Addendum Number 3

Lake Peachtree Spillway Replacement Project

August 4, 2017

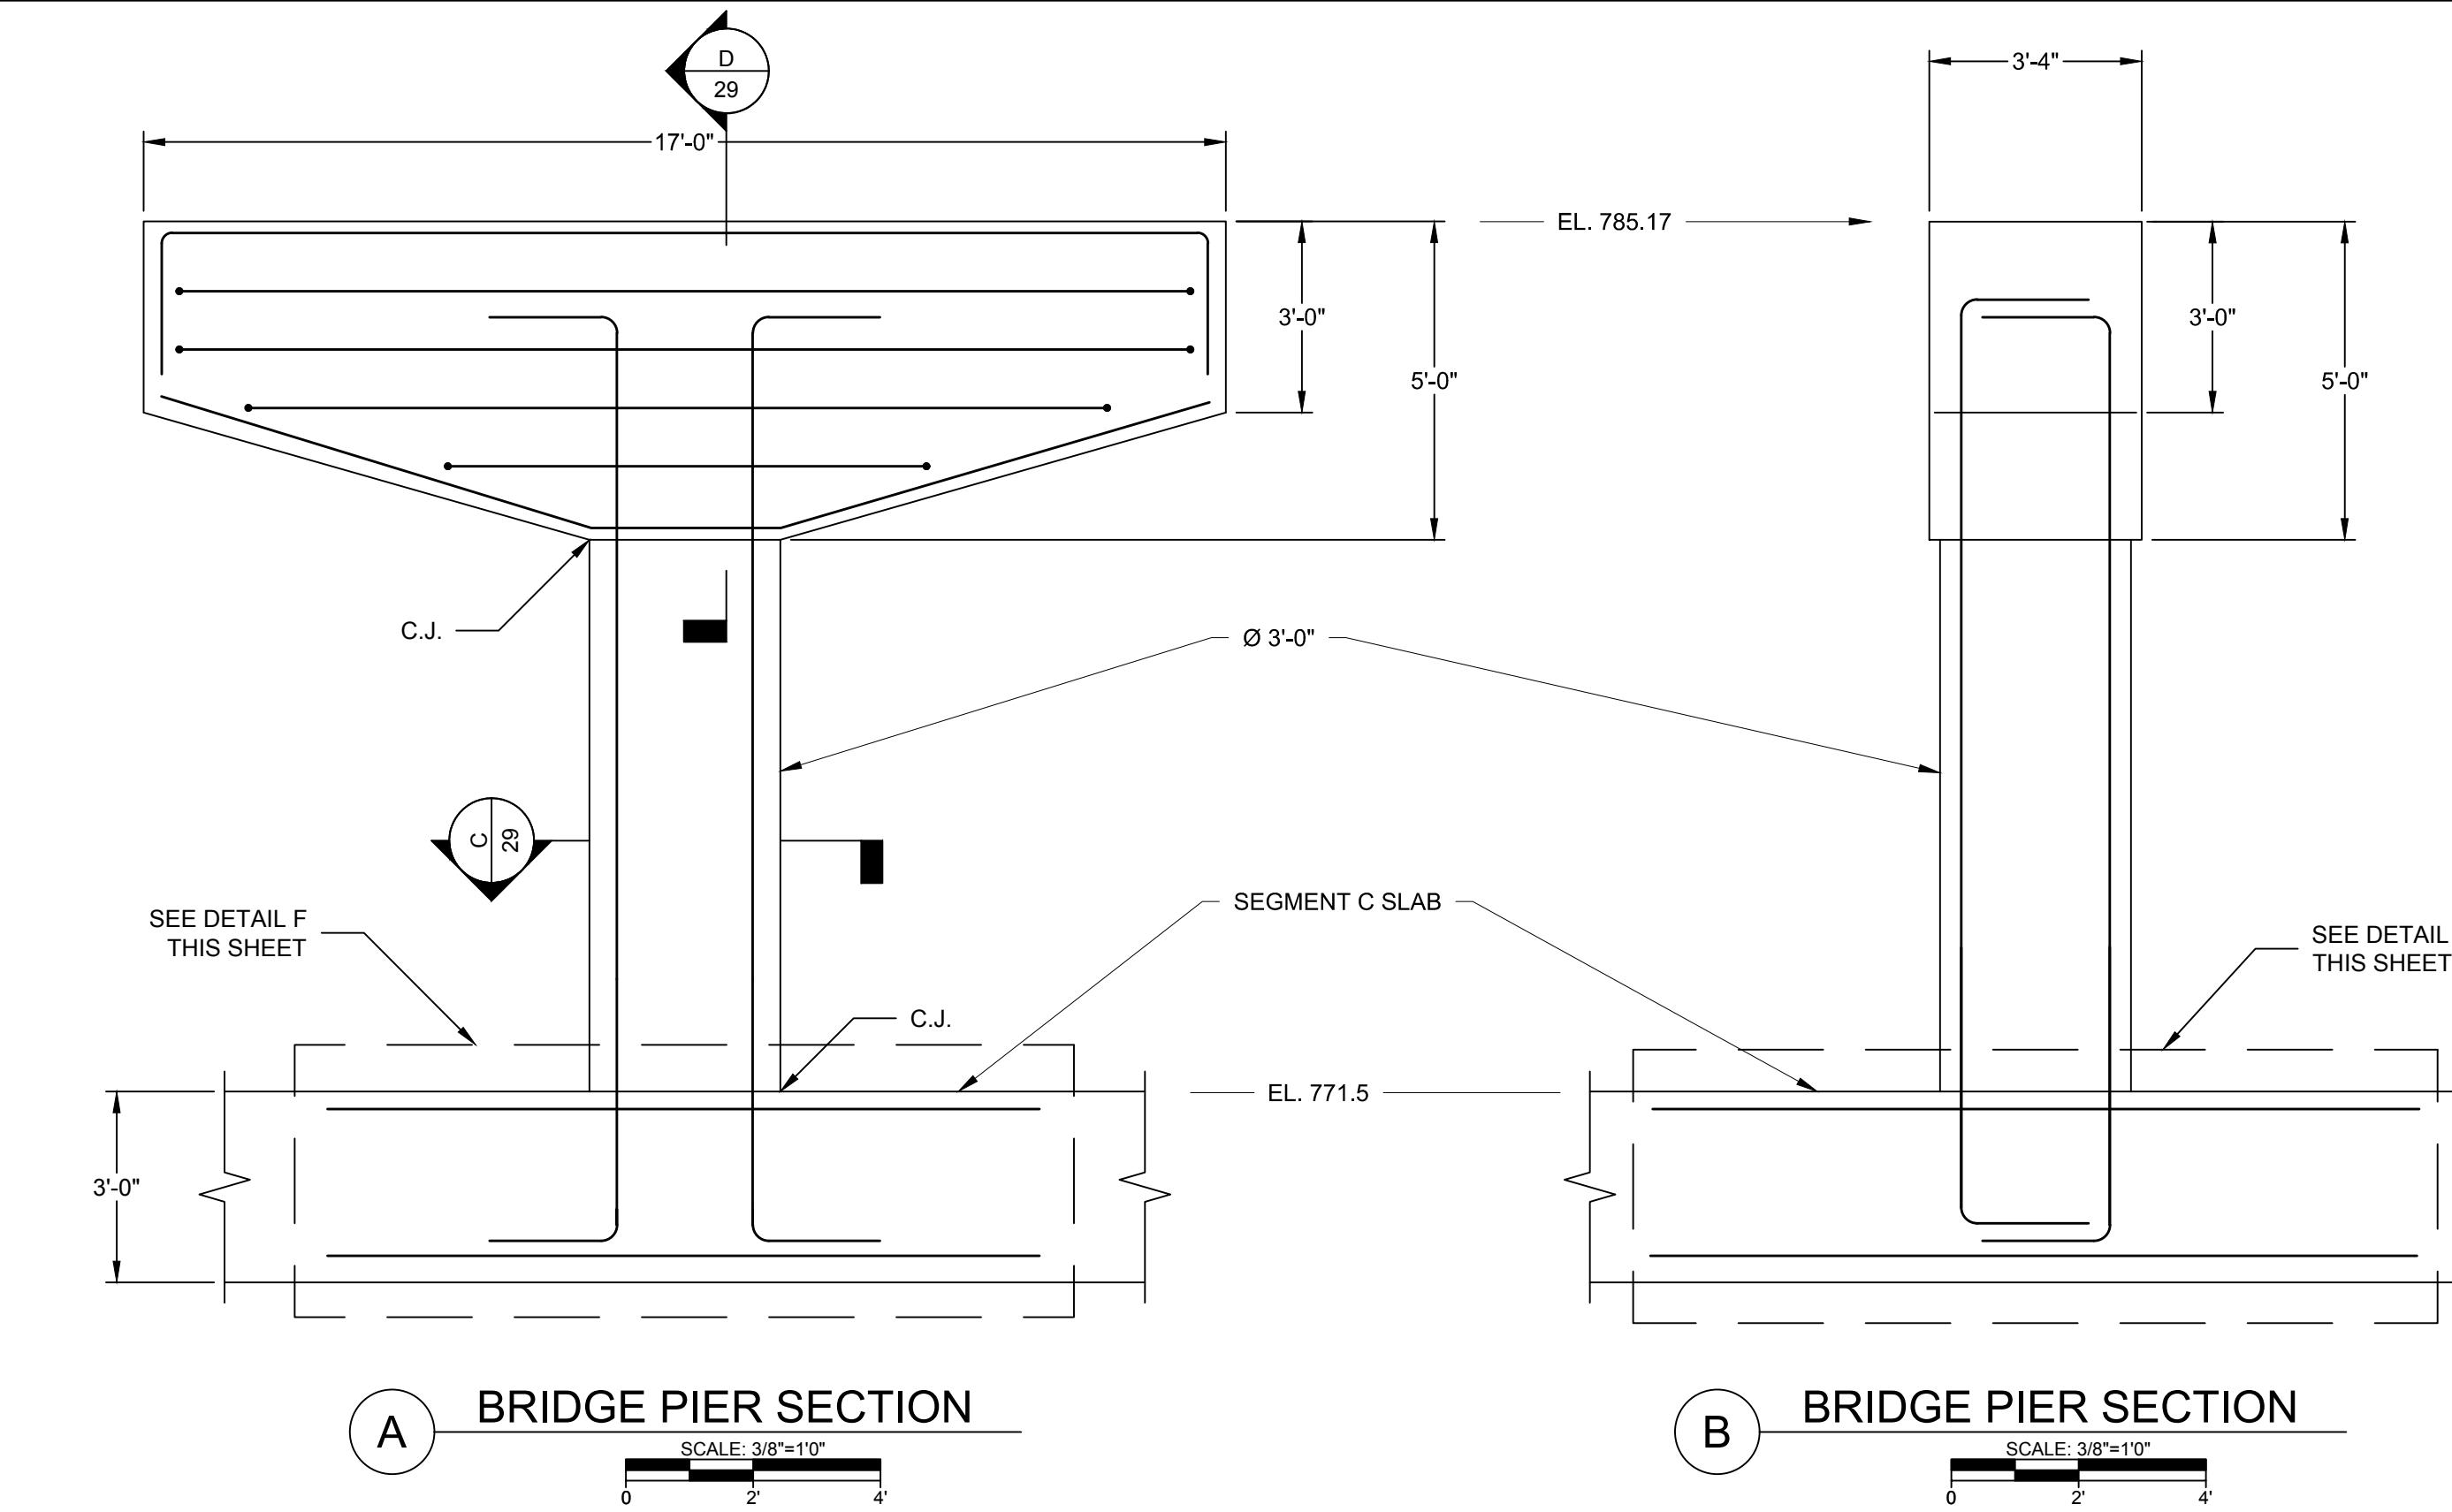
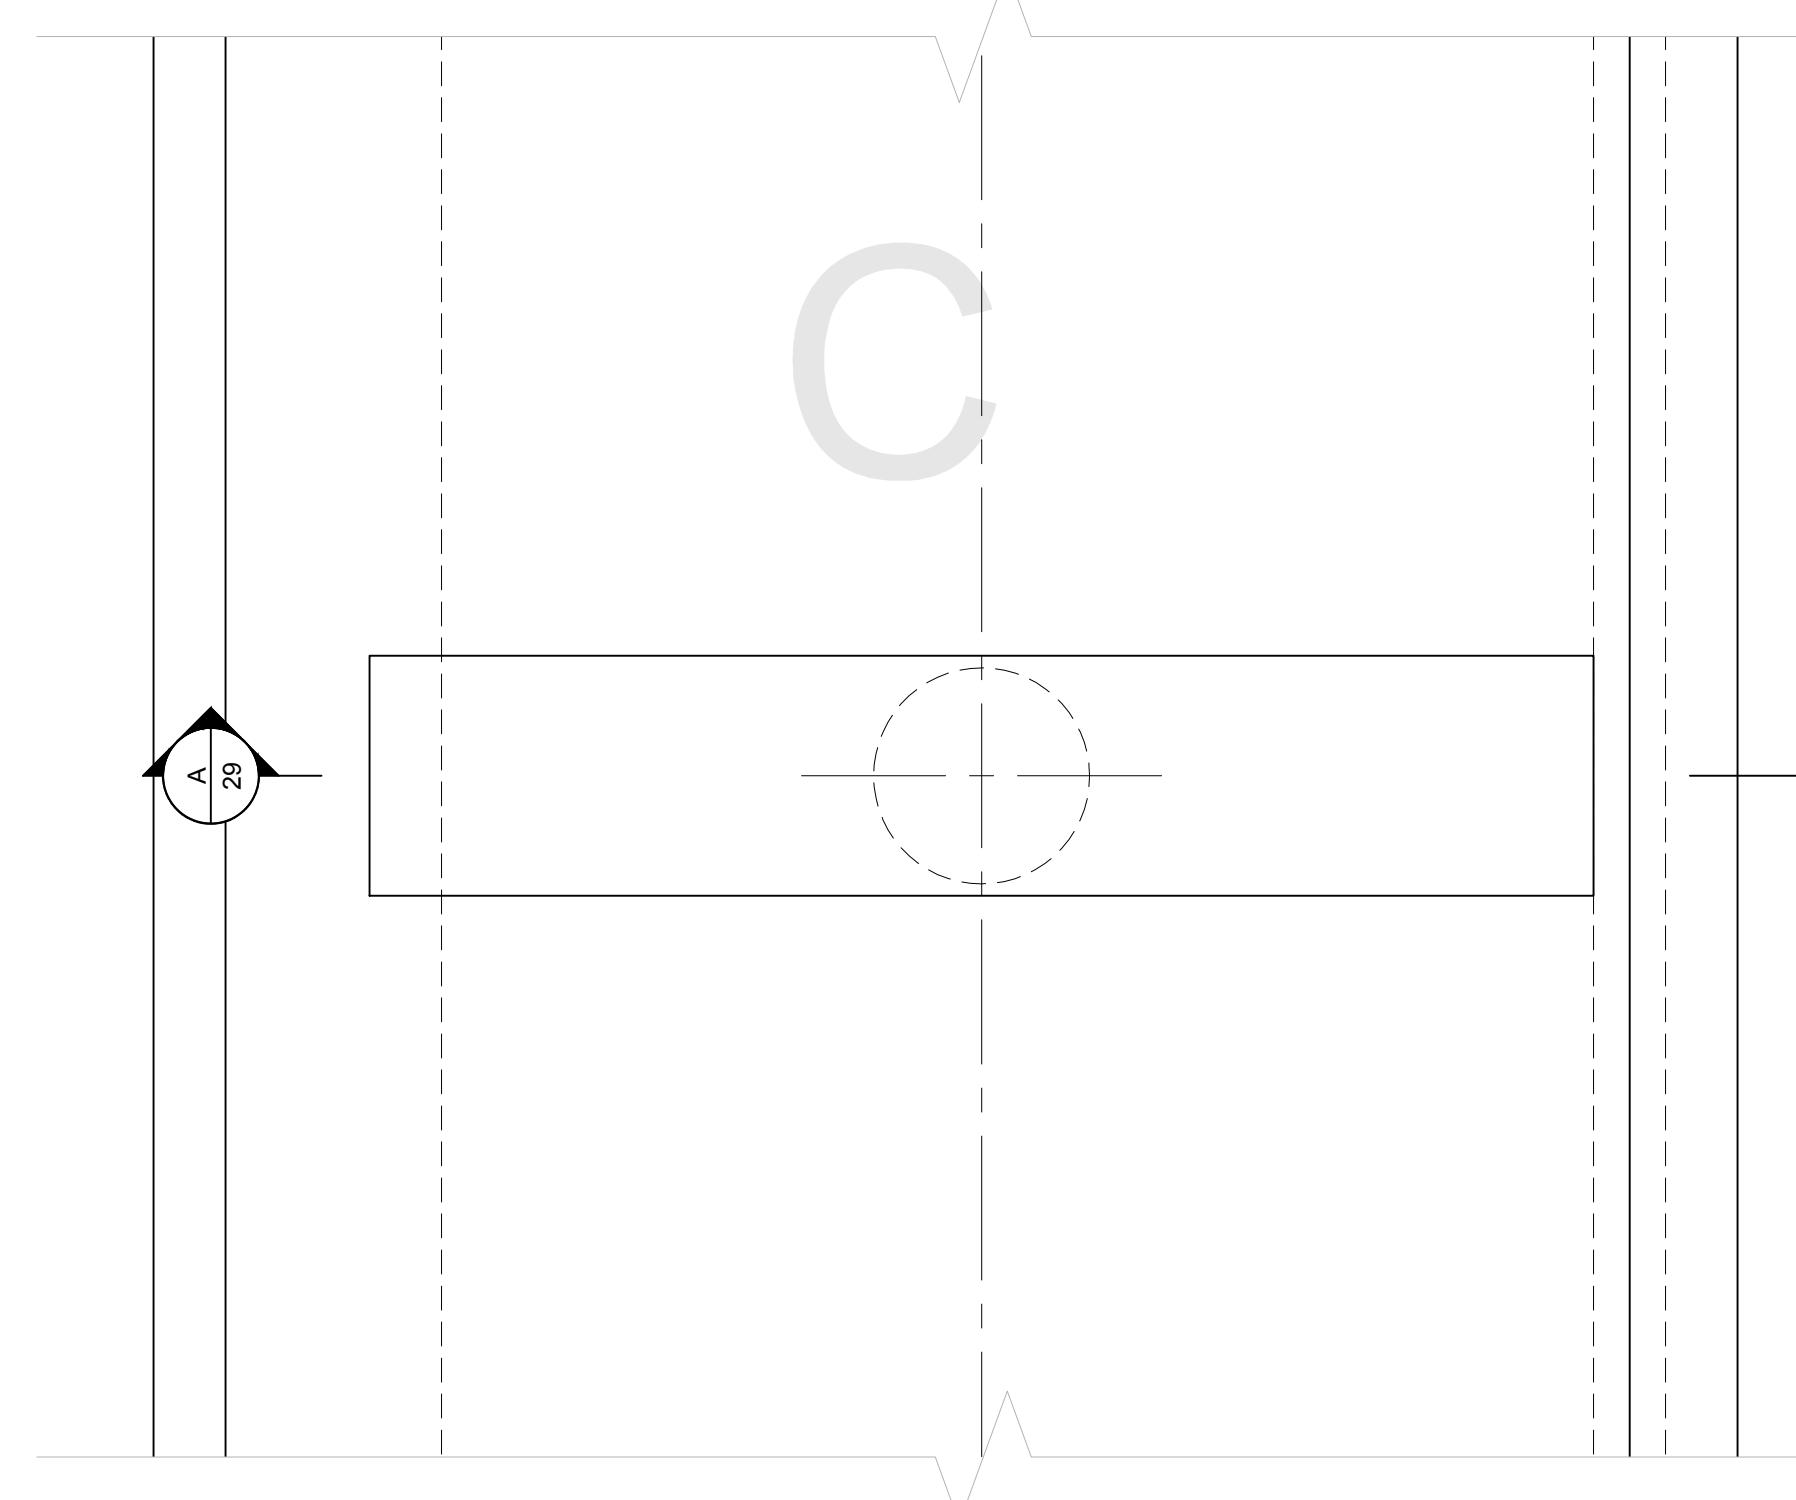
4. (Reference: Plan Sheet 29) The detail for the bridge pier elevation and section show different dimensions for the stem and the cap. Please confirm that the dimensions shown on the section details are correct.

- a. The dimensions shown on the section view are correct. An updated sheet depicting the bridge dimensions is appended for your convenience.
5. (Reference: Plan Sheets 33, 40, 43, 44) Please provide depths for the upper cut-off walls for slab sections G1, G2, H1, H2 and I1. Also provide rebar configurations for these walls.

NOTE: PROVIDE ADDITIONAL #4 @ 12" O.C. EACH FACE, EACH WAY IN A 10 FOOT BY 10 FOOT GRID CENTERED AROUND THE BRIDGE PIER.
